Olive Downs Coking Coal Project

Additional Information to the
Environmental Impact Statement

Response to IESC Advice

Figure 5-1

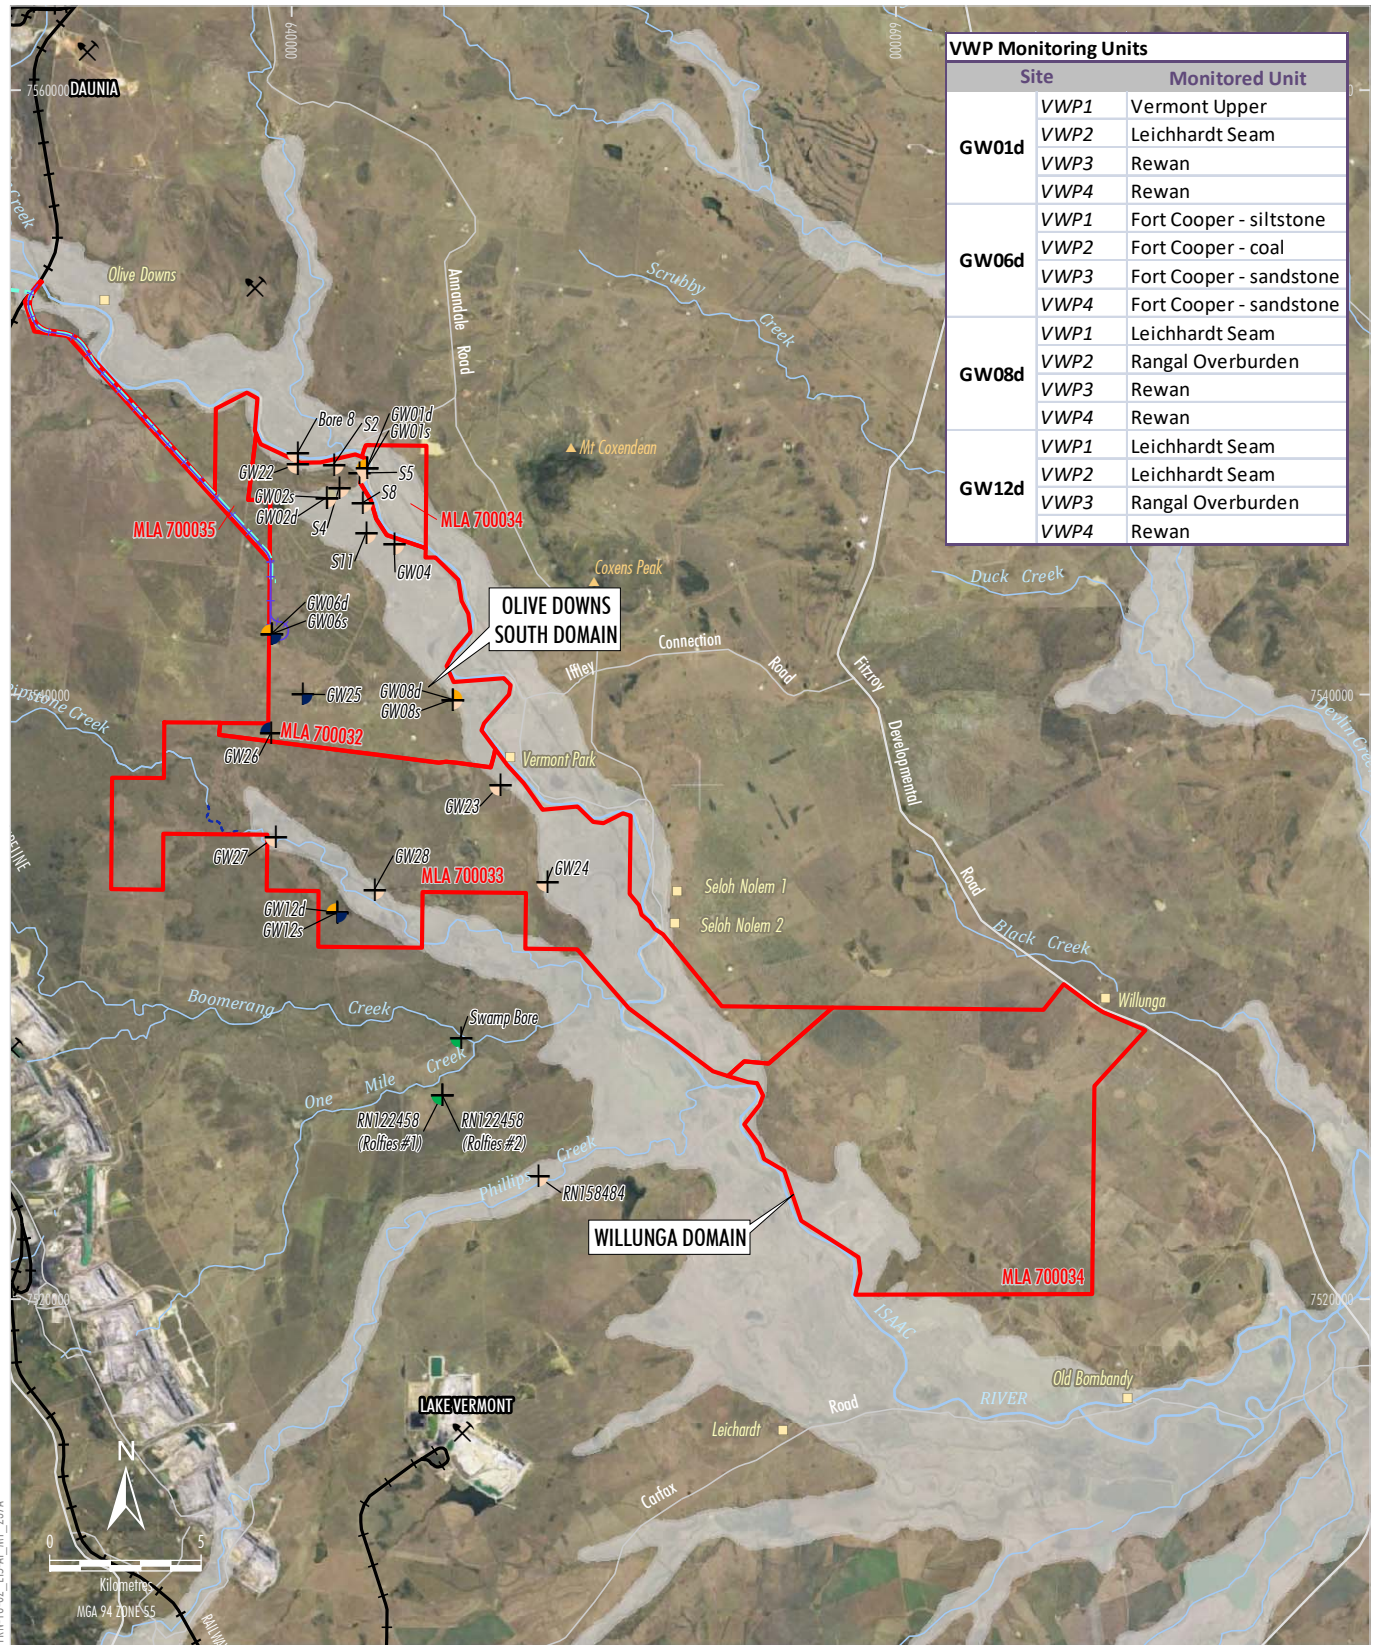
b) Update the numerical groundwater modelling once additional data have been collected

Pembroke proposes a network of reference and compliance bores be included in the EA Conditions for the Project, including proposed new monitoring locations to add to existing baseline datasets. The Stage 1 reference and compliance bores are listed in Table 5-1 and shown on Figure 5-1. As stated on Page 4-86 of the draft EIS, recording of groundwater levels from existing monitoring bores and VWPs would continue and would enable natural groundwater level fluctuations (such as responses to rainfall) to be distinguished from potential groundwater level impacts due to depressurisation resulting from proposed mining activities. Since lodgement of the draft EIS, groundwater monitoring has continued, and updated groundwater quality data has been included in Section 13.

Pembroke's approach is consistent with the IESC's suggestion. If after two years after installation of additional monitoring bores there is a significant deviation from the model predictions identified, then the model would be subject to review. The review process would involve re-running the groundwater model, confirming the revised predictions, undertaking any additional consultation deemed necessary and adjusting the proposed control measures as required.

Figure 5-8: Comparison of DataDrill vs Stochastic Rainfall Data

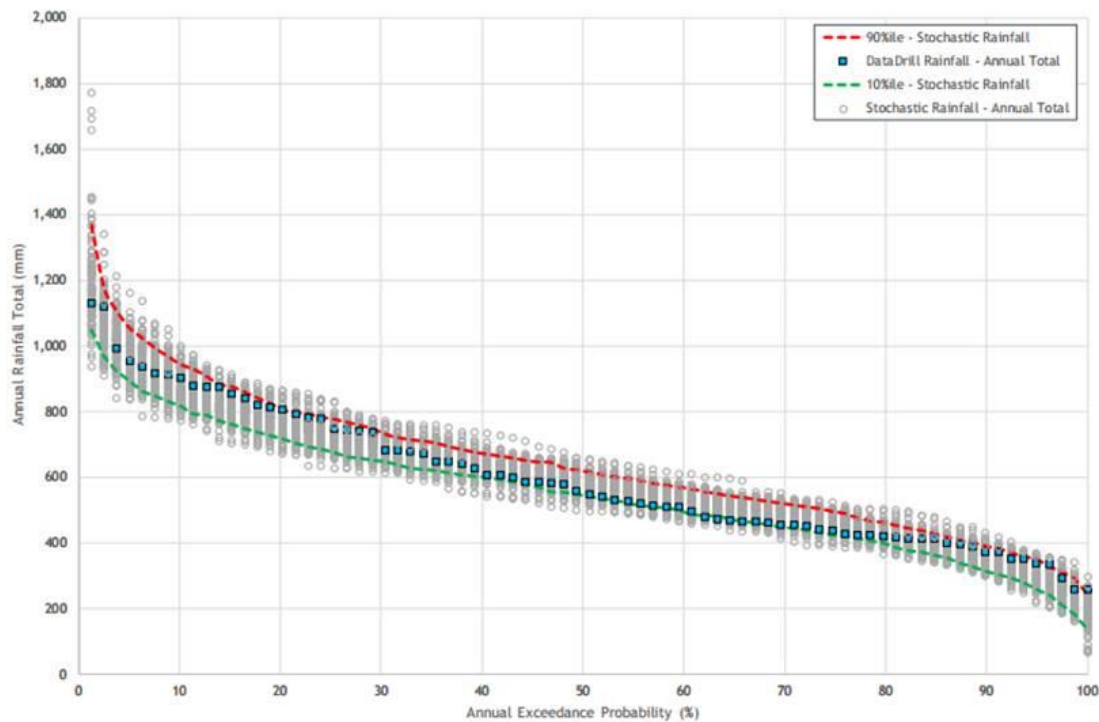
The natural inputs to the mine water management system are based on an Australian Water Balance Model (AWBM) (which has been calibrated to only one catchment of the Isaac River) and the use of stochastic rainfall replicates. It is concerning that the median observed annual rainfalls coincide with the lower (90%) bound of the synthetic series (Figure 5.8, Appendix E), which suggests that the typical annual synthetic inflows are biased high. However, this “high bias” would be partially offset by the underestimation of streamflows obtained using the AWBM model (Figure 7.5, Appendix E). Overall, it is possible that the water usage requirements associated with the predicted 10% (dry) climatic conditions are representative of the likely future typical (50%) requirements, without allowing for climate change. For example, the external makeup requirements associated with a 10% probability of exceedance might be better regarded as being associated with median climatic conditions. If this is of critical concern, then the efficacy of the stochastic rainfall replicates should be revised to be more consistent with local observations.

As described in Section 5.2.2.1 of the draft EIS Surface Water Assessment (Hatch, 2018) report, a stochastically generated rainfall dataset was produced to provide a sufficient number of climatic sequences, given the long mine life. This stochastic rainfall dataset was generated using the Stochastic Climate Library (SCL) software, using the SILO rainfall data as the source data. The SCL software is effectively a “black box” type program, and does not provide any ability to modify parameters or settings which can change the results.

To test the efficacy of the program, WRM compared the source (SILO) rainfall data against the generated rainfall data (Figure 5-8 of the Surface Water Assessment reproduced below). This showed that, when ranked, the historical annual rainfall totals were generally within the 10th and 90th percentile bounds of the stochastic annual totals.

Some of the historical data was closer to the 10th percentile, some closer to the 90th percentile and some near the median. In WRM's opinion, the stochastically generated data was successfully replicating the historical data with a reasonable amount of variation and the use of the adopted stochastic rainfall dataset is acceptable for the following reasons:
